IAIN FROST SUBDIVISION

APPLICATION NUMBER 6 DATE August 2, 2012
APPLICANT Iain Frost Subdivision
REQUEST Subdivision

DETAIL SITE PLAN

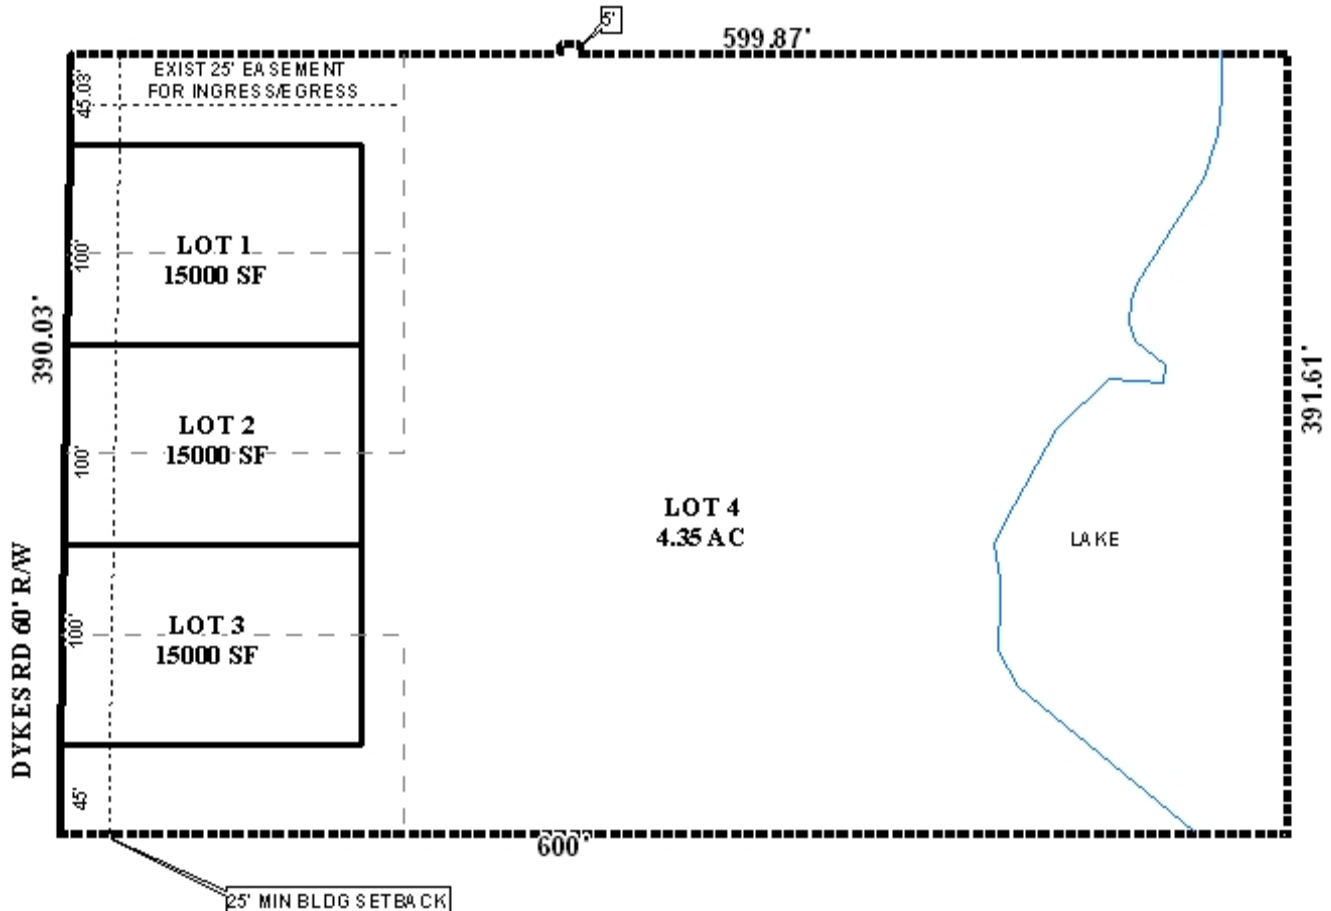
The applicant proposes that Lot 4 be a "flag" lot, with two proposed 45'± wide by 150'± long poles connecting the lot to Dykes Road South. There are currently five other "flag" lots in the area that were approved by the Planning Commission at its February 6, 1992; June 18, 1998; September 4, 2003; and May 19, 2005 meetings respectively. Because "flag" lots are not uncommon in this area, it may be appropriate to waive Section V.D.1. of the Subdivision Regulations. The plat that was approved for this site as part of Bill Robinsons Subdivision, Resubdivision of Lot 5 in 2011, illustrated Lot 4 as a "flag" lot; however, the layout was more ideal, with Lot 4 having one 90'± wide pole instead of two smaller poles.

It should also be noted that upon reviewing City of Mobile aerial photographs of the site from 2010, the driveway to the existing residence on Lot 4 seems to be located through the currently proposed Lot 2, with no plans illustrated to relocate the driveway to the newly proposed poles for Lot 4. On the previously approved plat the driveway of Lot 4 was located in the pole for that lot.

It should also be noted that the proposed Lot 4 is 90'± wide at the building setback line and 600'± deep. Section V.D.3. of the Subdivision Regulations states that the maximum depth of any lots, exclusive of unusable land shall not be more than 3.5 times the width at the building setback line. Using this calculation, proposed Lot 4 is 285'± deeper than allowed.

The 25-foot minimum building setback is shown and labeled on the preliminary plat; however, the setback line for Lot 4 should be revised to illustrate it from where the poles meet the “flag”. If approved the minimum building setback should be illustrated on the Final Plat.

- 1) lot shapes not in compliance with Section V.D.1. of the Subdivision Regulations;
- 2) lot width-to depth ratio not in compliance with Section V.D.3. of the Subdivision Regulations; and
- 3) driveway of Lot 4 would encroach on Lot 2.
